ATTACHMENT D1

**Uranium One ISR Wellfield Hydrologic Impact Analysis
(Response to RAI 56)**

RAI 56

POTENTIAL IMPACTS FROM IRRIGATION WELL SMITH #1

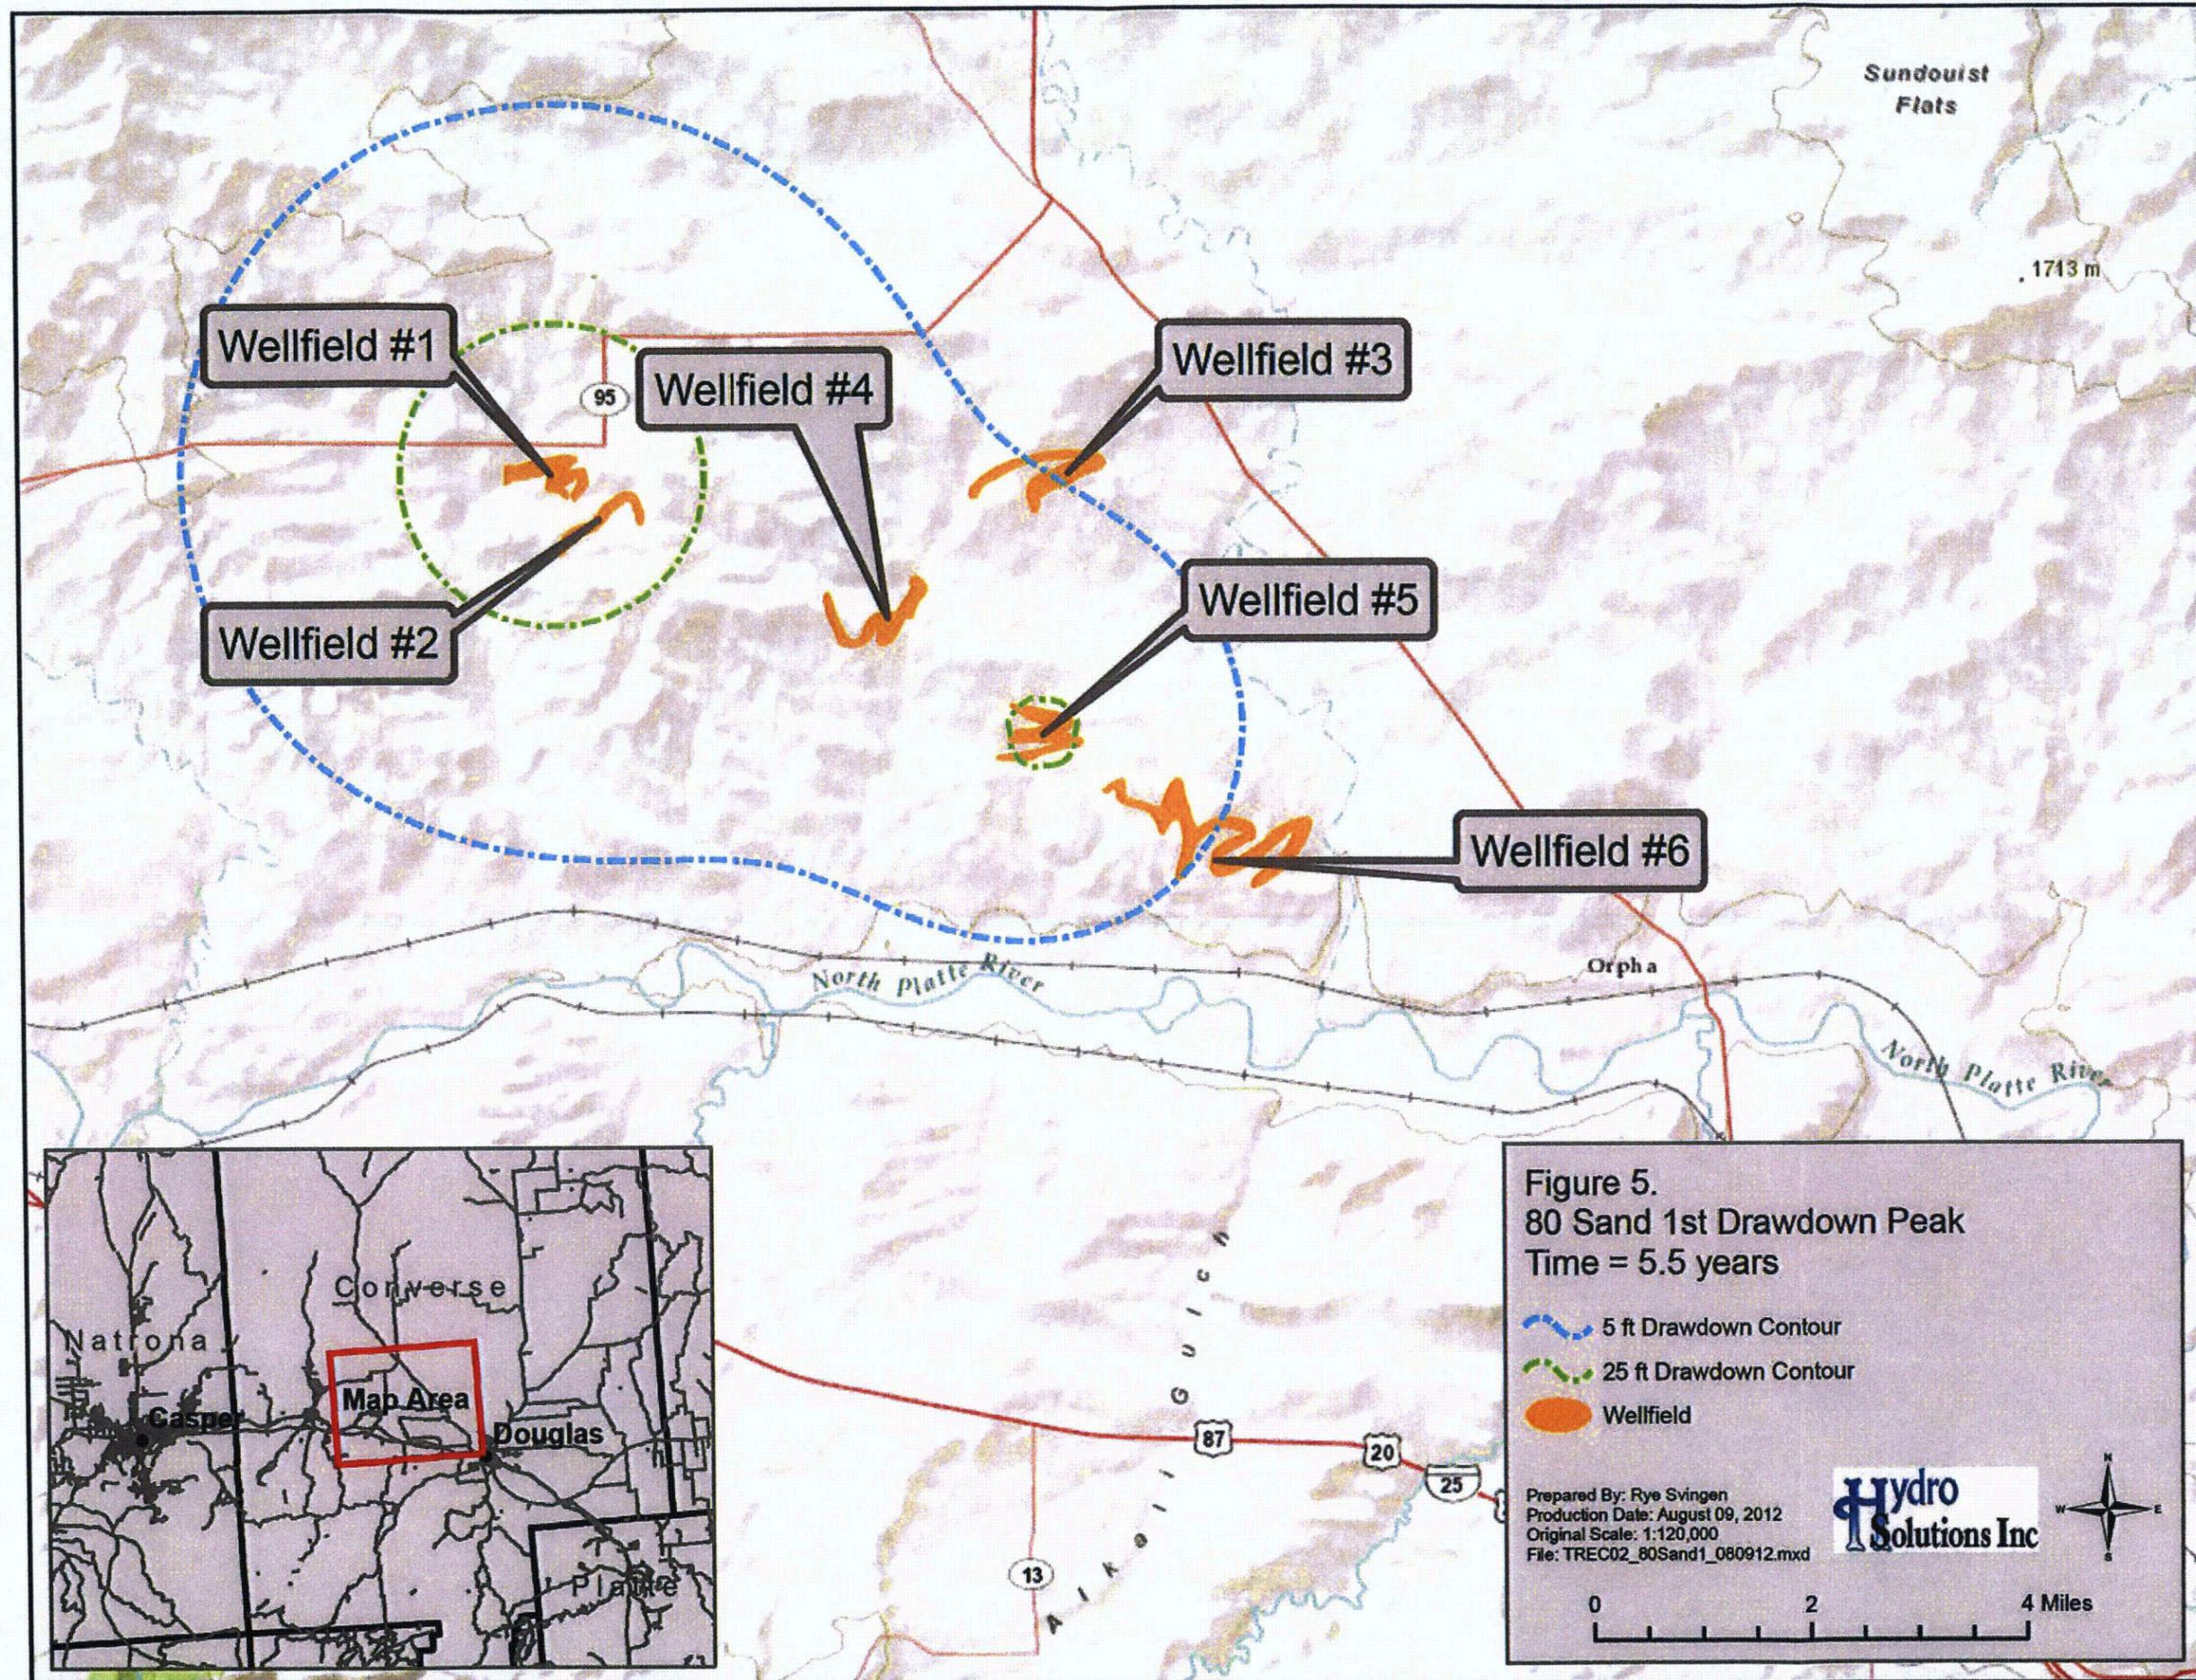
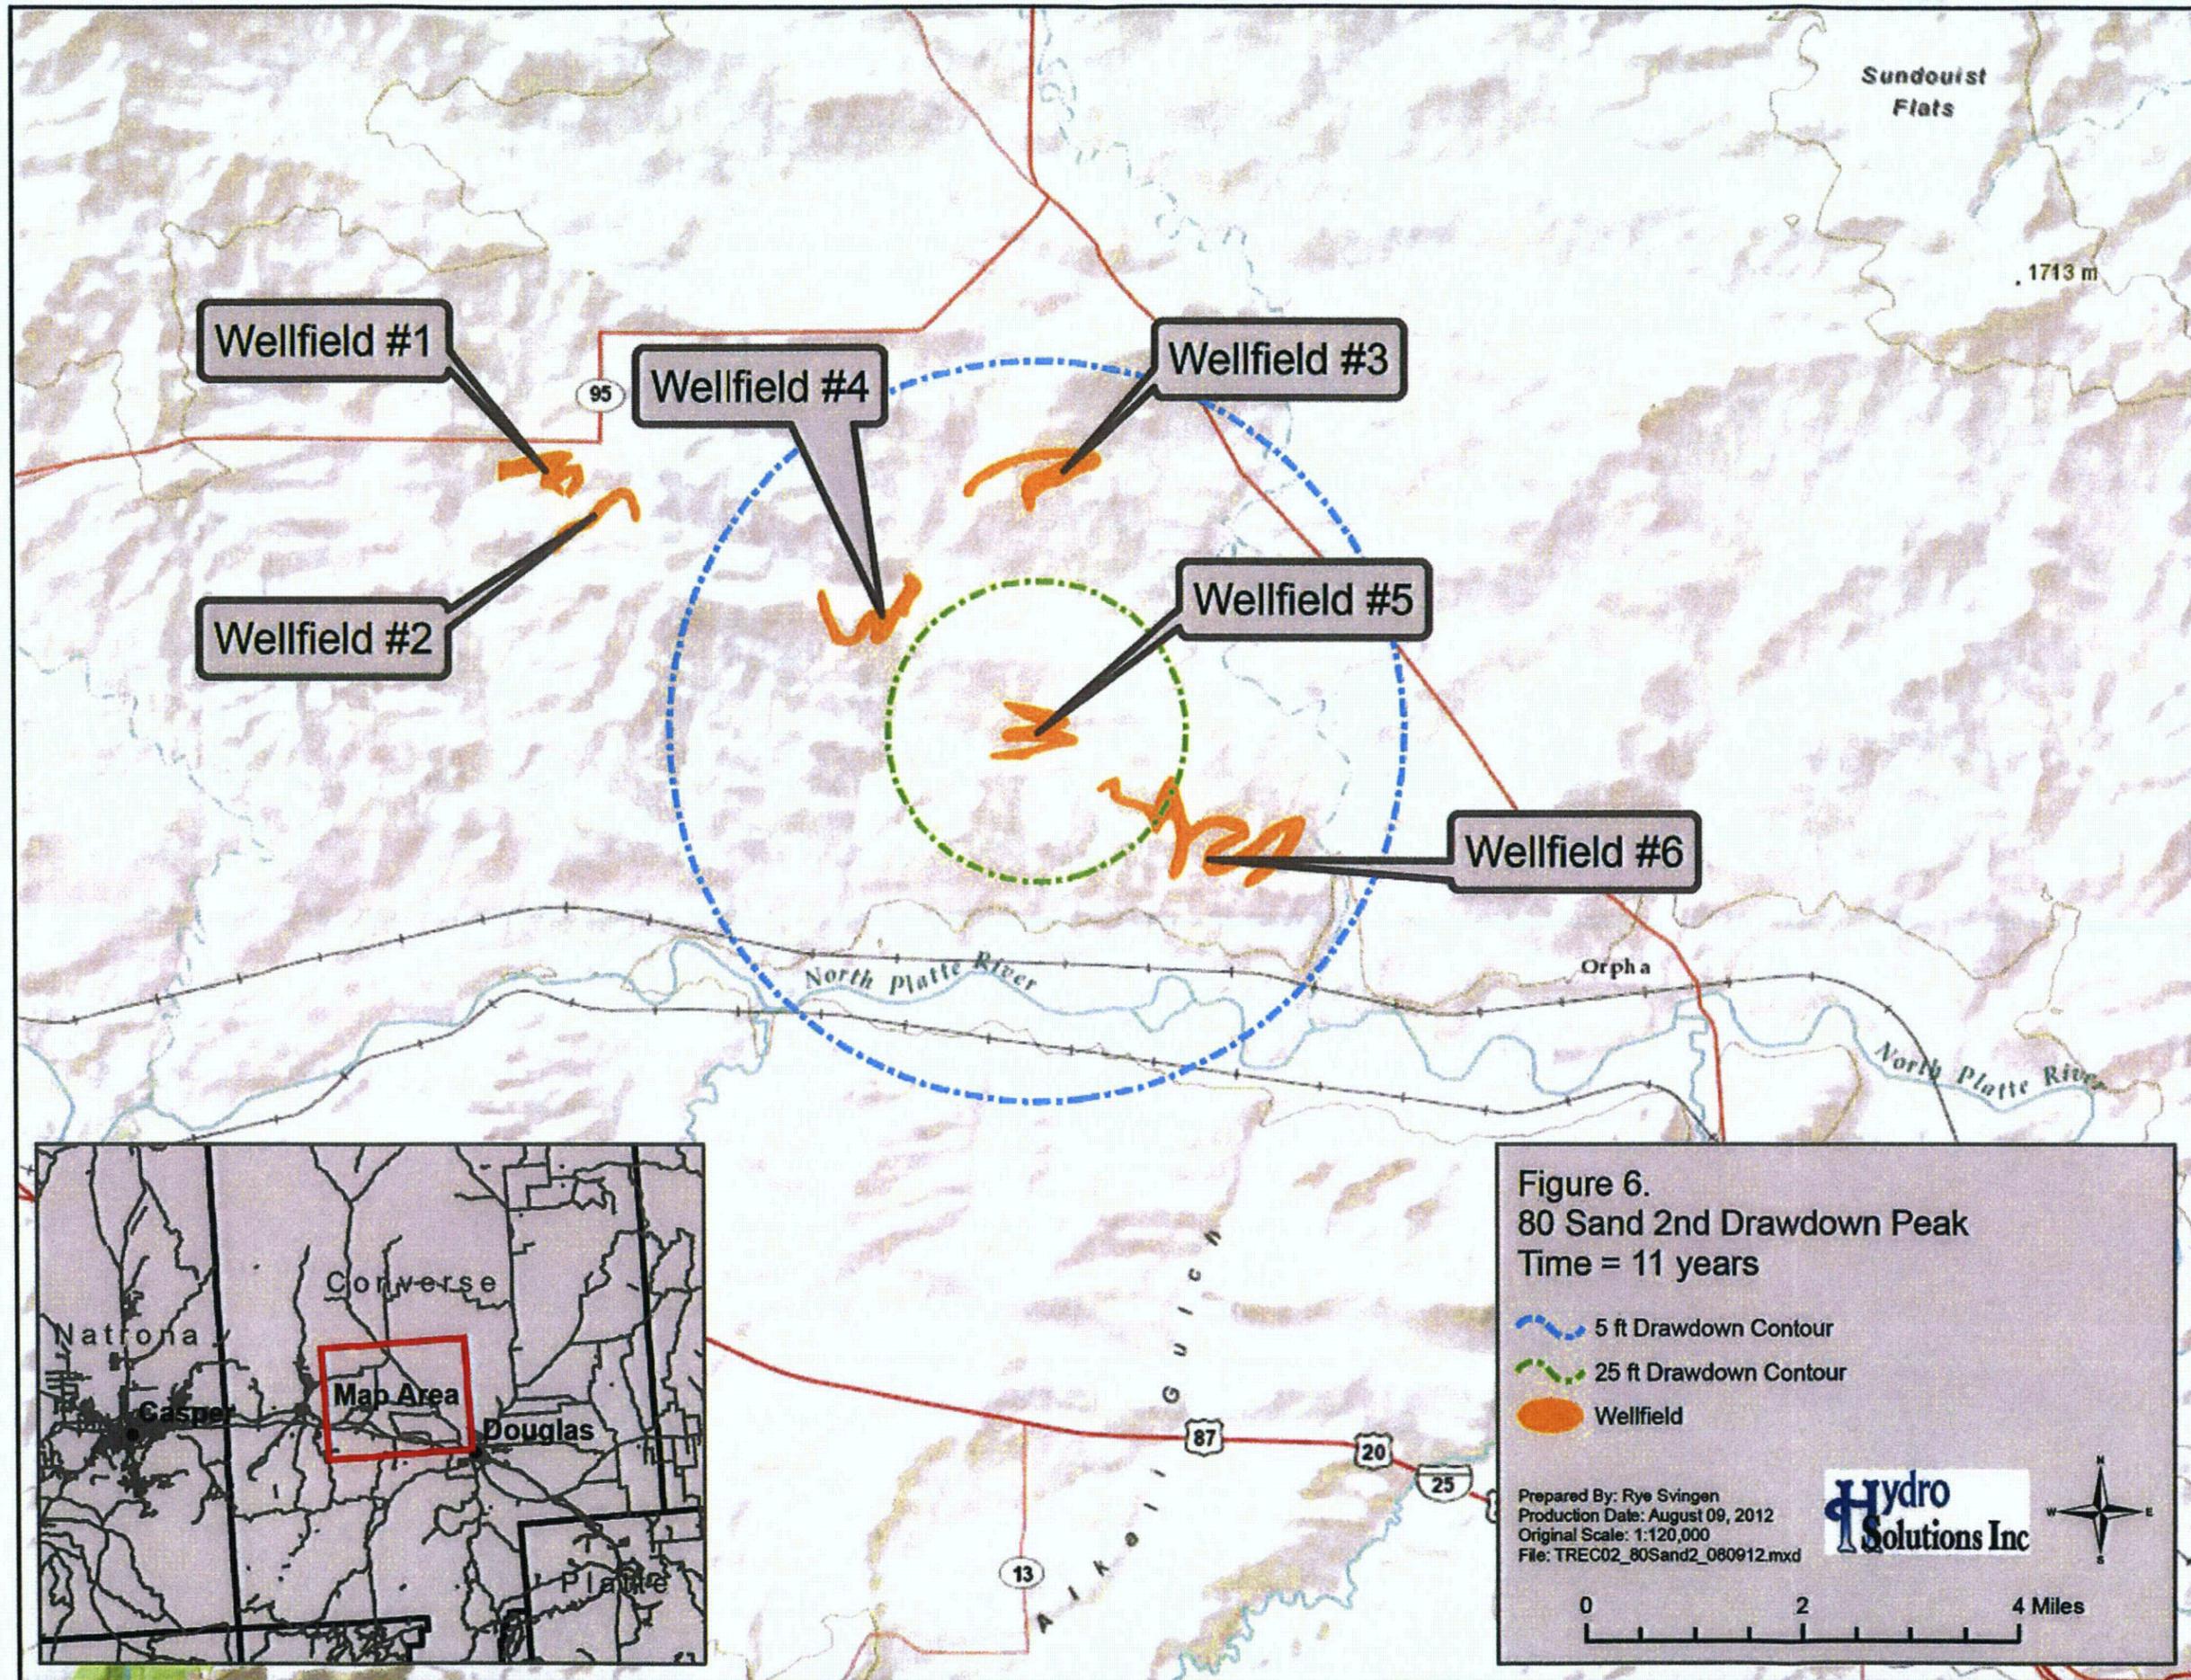
TR Section 3.1.6.1 provides the ROI for the 90 sand, 80 sand, and 70 sand as 550 ft, 500 ft, and 750 ft, respectively, based on the aquifer pumping tests. The TR also states there would be no impact to groundwater levels outside the project boundaries based on these estimates for the proposed bleed rate (15-45 gpm). These ROI were derived based on observations during the aquifer testing of these sands but the TR provided no calculations to support these numbers. Staff does not agree with Uranium One's definition of ROI. In practice, the ROI is defined by a function of transmissivity (T), time (t) and storage coefficient (S) in consistent units (Bear, 1979).

Staff requires the ROI and drawdown which will be realized at each satellite to assess the impacts of consumptive use on surrounding private wells and to provide reasonable assurance of the safe operation of the satellites.

Uranium One should provide: (a) the ROI using the estimated T, S and the time of production and restoration for each satellite wellfield; and (b) a prediction of the drawdown for each satellite wellfield within 2 km for each phase of operation using the appropriate consumptive use (e.g. 15-45 gpm).

A Theis-based analytical drawdown model for the 70, 80 and 90 Sand units at the proposed project was completed using site-specific aquifer parameters. The production sands of the Ludeman Project satisfy the assumptions required by the Theis model to the extent generally accepted for this type of hydrogeologic evaluation. Project-specific assumptions and limitations have been noted and discussed in this Memorandum. Model inputs were entered into AQTESOLV software, and graphs were produced showing the predicted time-drawdown behavior of the proposed project wellfields. Drawdown contour

Drawdown contours produced by the model were typically circular to somewhat elliptical in shape, depending on the distribution of active pumping centers in a given aquifer. At the time(s) of maximum drawdown, 25 foot drawdown contours for the 70, 80 and 90 Sand units had maximum radii that ranged between about 1.2 to 2.4 miles from their approximate pumping centers (wellfields) at the Ludeman site. Five foot drawdown contours for the 70, 80 and 90 sands typically had radii of approximately 3.4 to 4.8 miles from the pumping centers. A summary of approximate radial distances to the five and 25 foot drawdown contours for each aquifer is presented on Table 5.

Graphs showing the modeled time-drawdown characteristics of the pumping centers in each aquifer over the duration of the project are presented on Figures 1–3. Results of the analytical drawdown modeling are also presented as drawdown contour maps on Figures 4–8. Due to the operational schedules of the 80 and 90 Sand units, two distinct drawdown peaks were noted in the model output, which correspond to unique areal drawdown patterns. Thus, individual contour maps were prepared for both the first and second peaks in these cases.
